What do Cays residents want in Cays Park?

KEY FINDINGS from the 2021 & 2023 Surveys

Kevin Reilly
11/1/2023

COMPROMISE SOLUTION

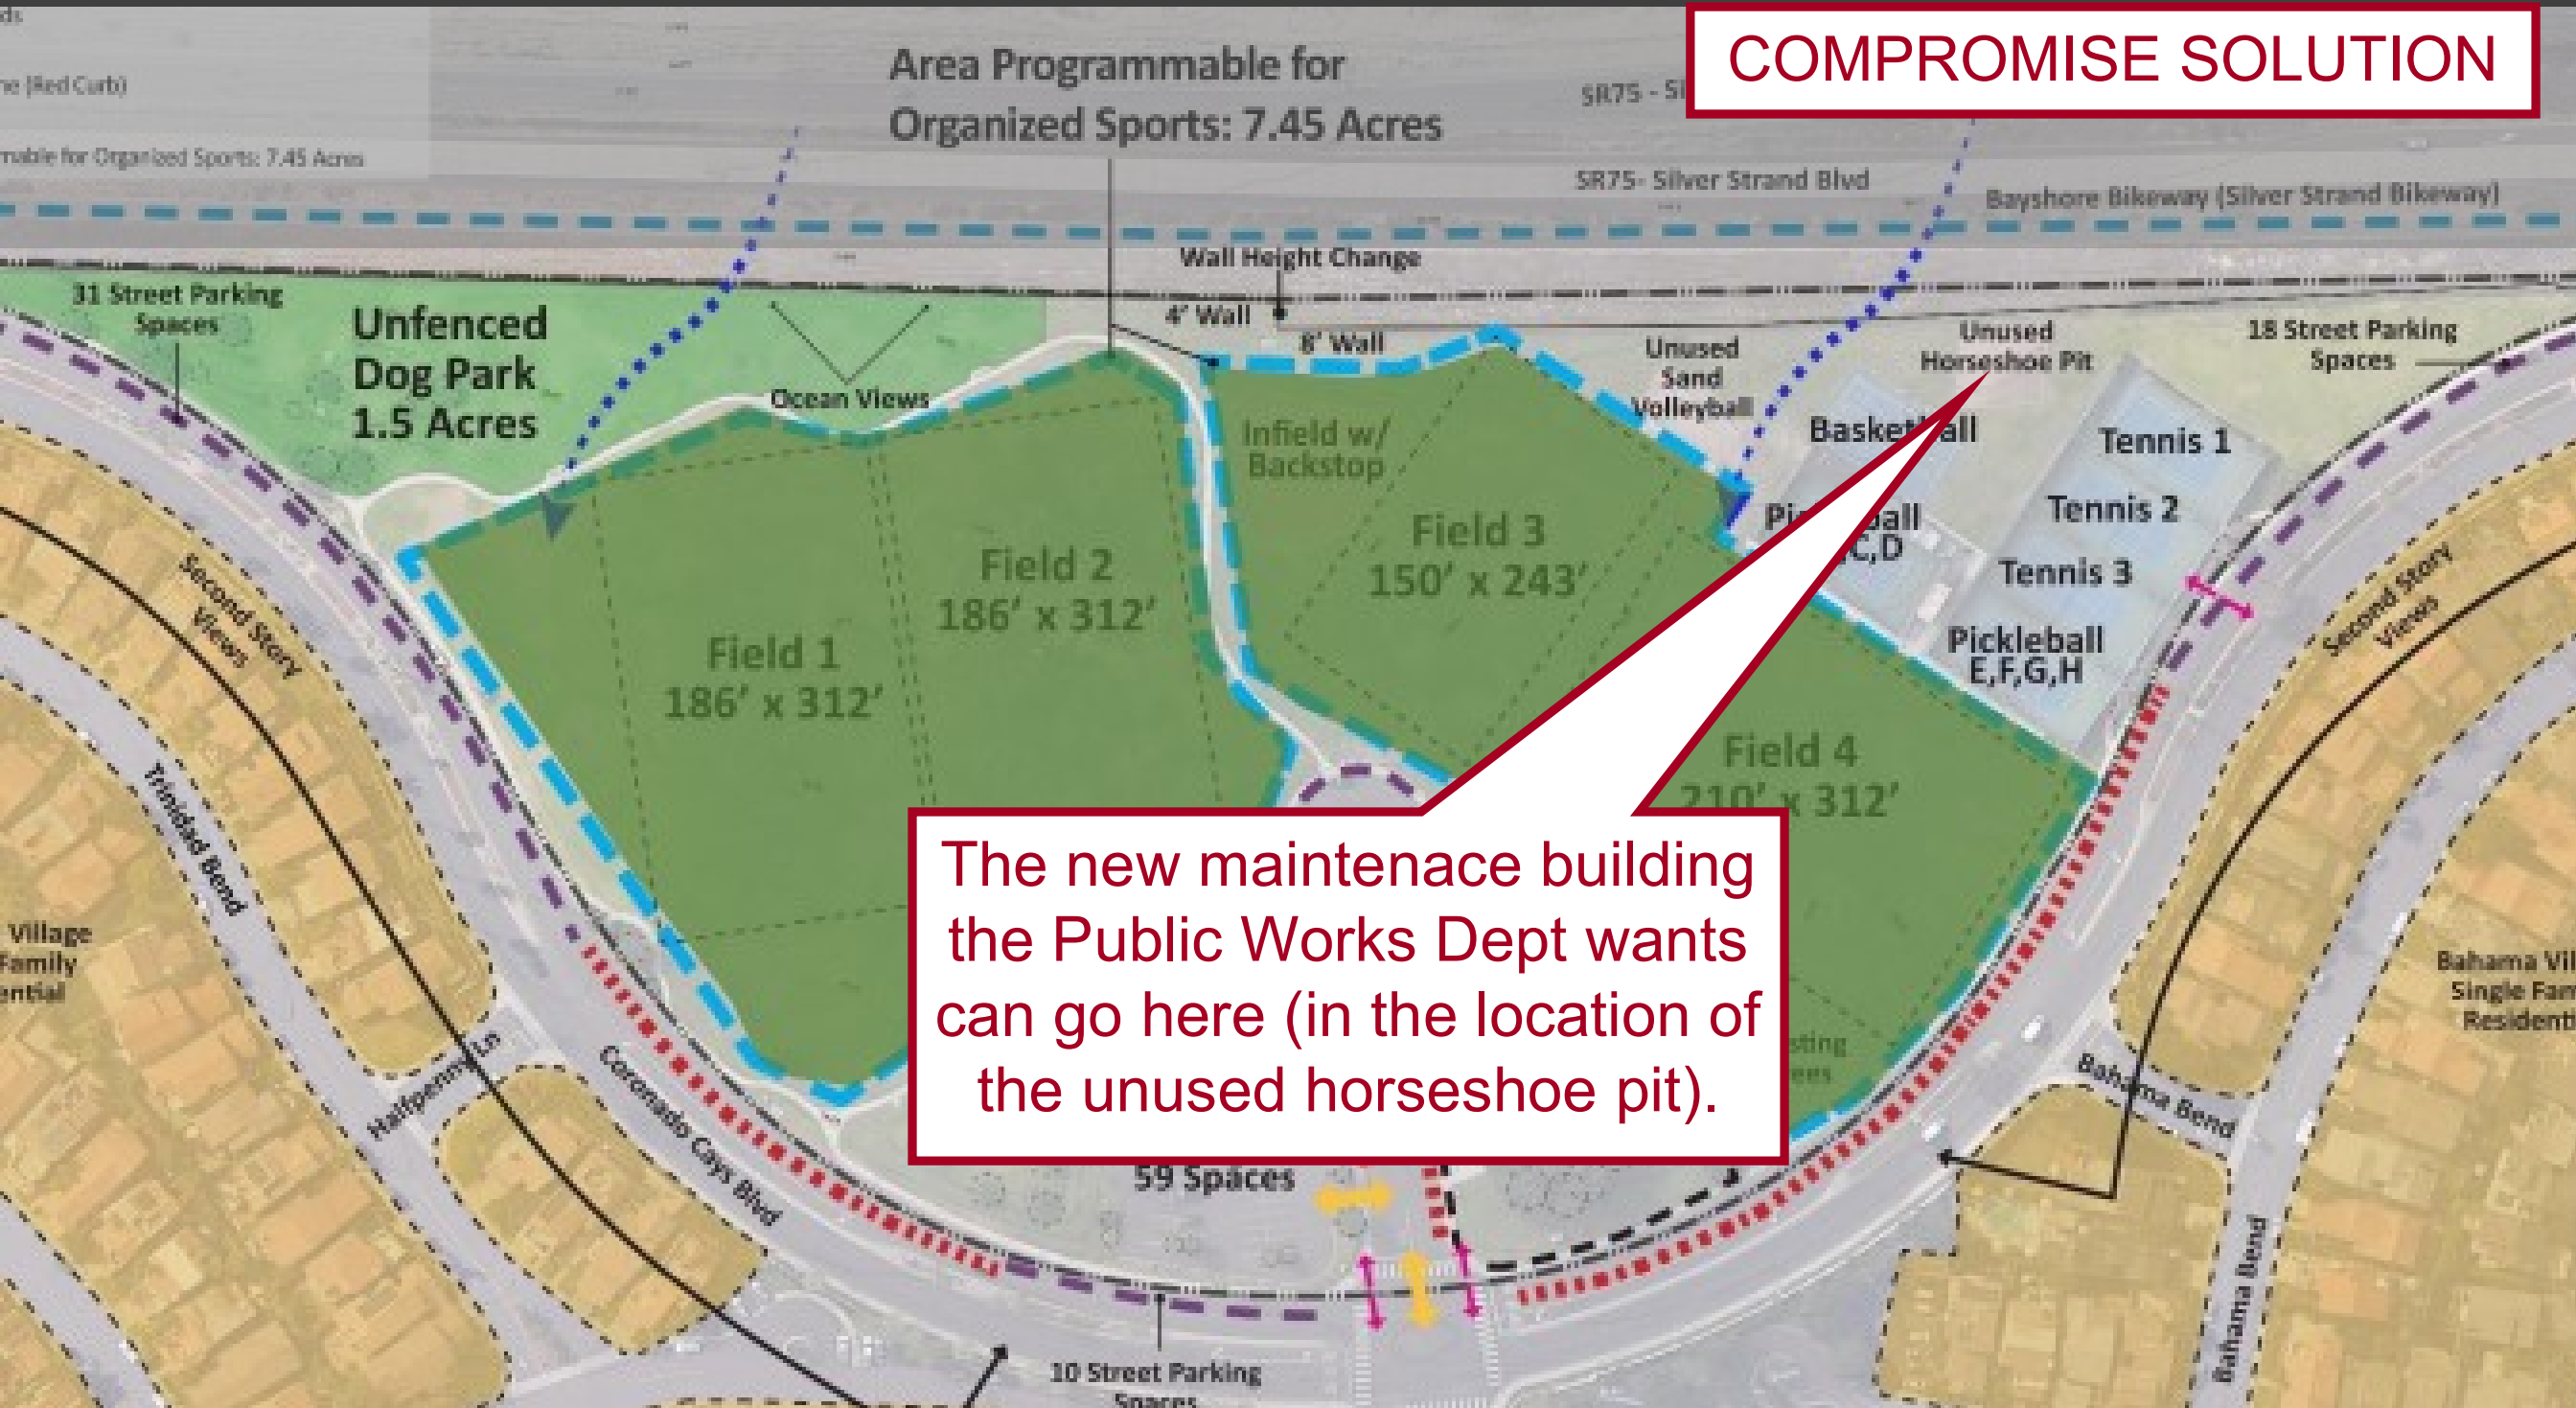
The new maintenance building the Public Works Dept wants can go here (in the location of the unused horseshoe pit).

COMPROMISE SOLUTION

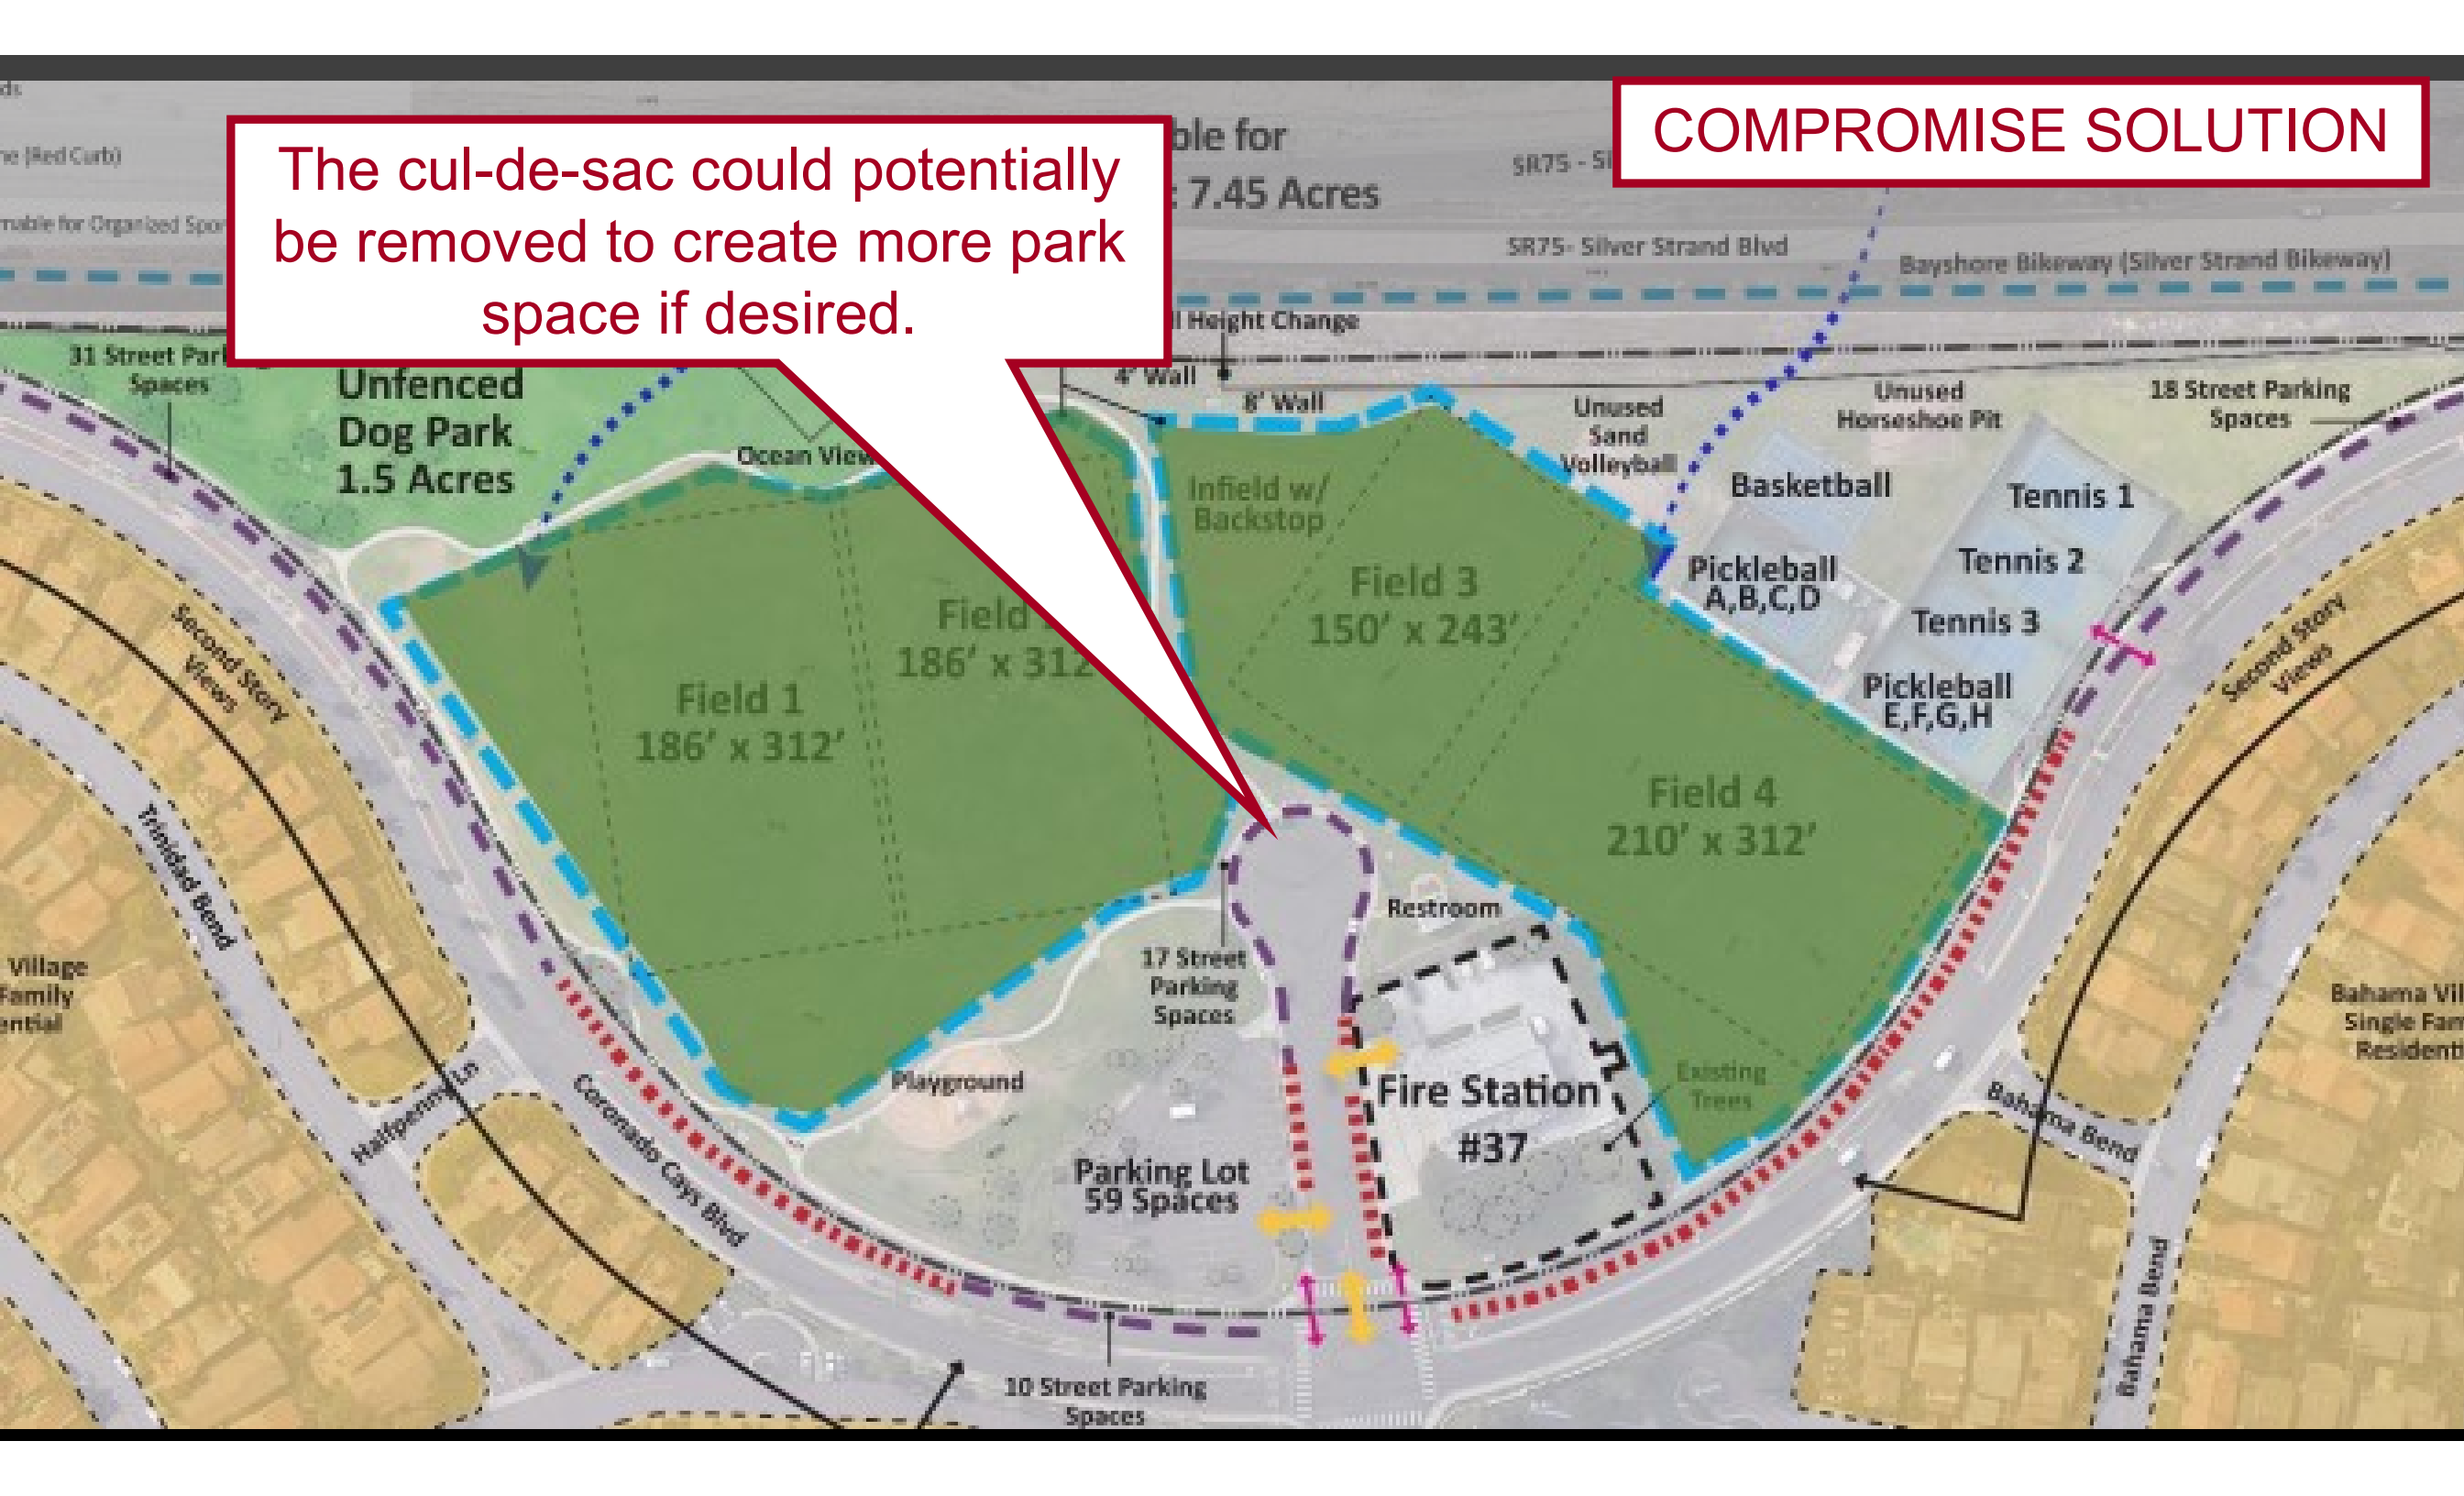
The cul-de-sac could potentially be removed to create more park space if desired.

COMPROMISE SOLUTION

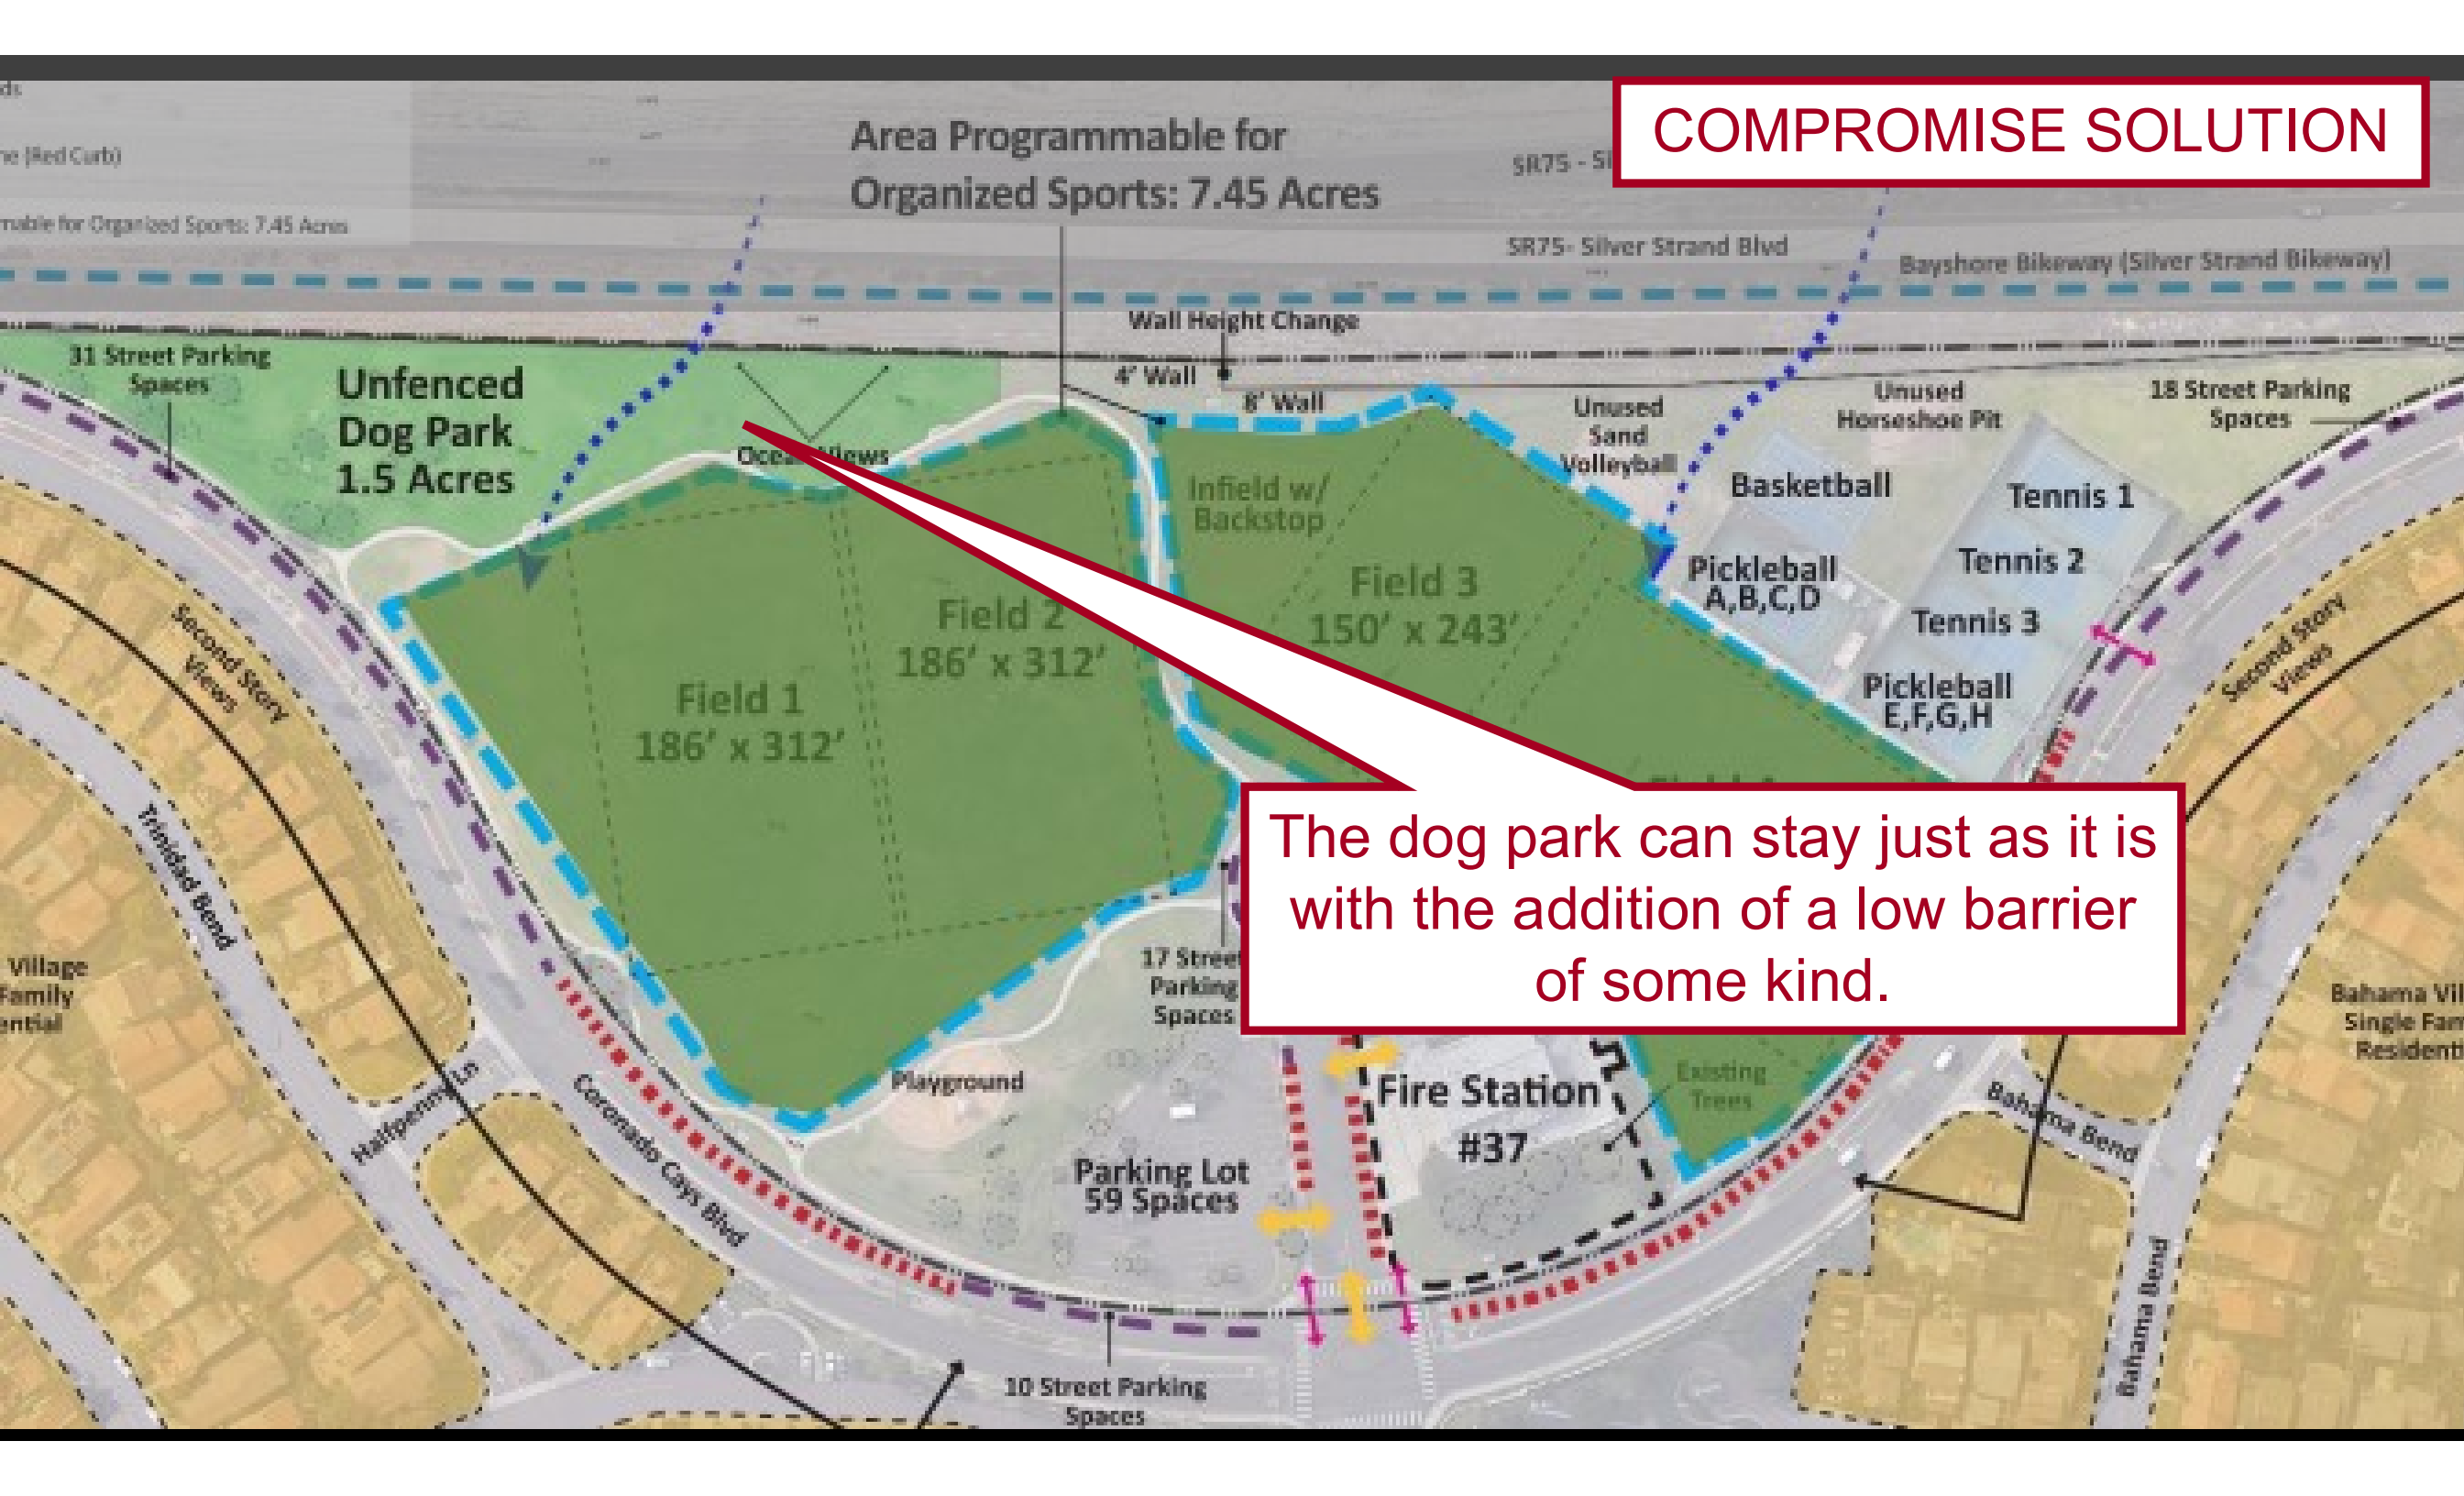
The dog park can stay just as it is with the addition of a low barrier of some kind.
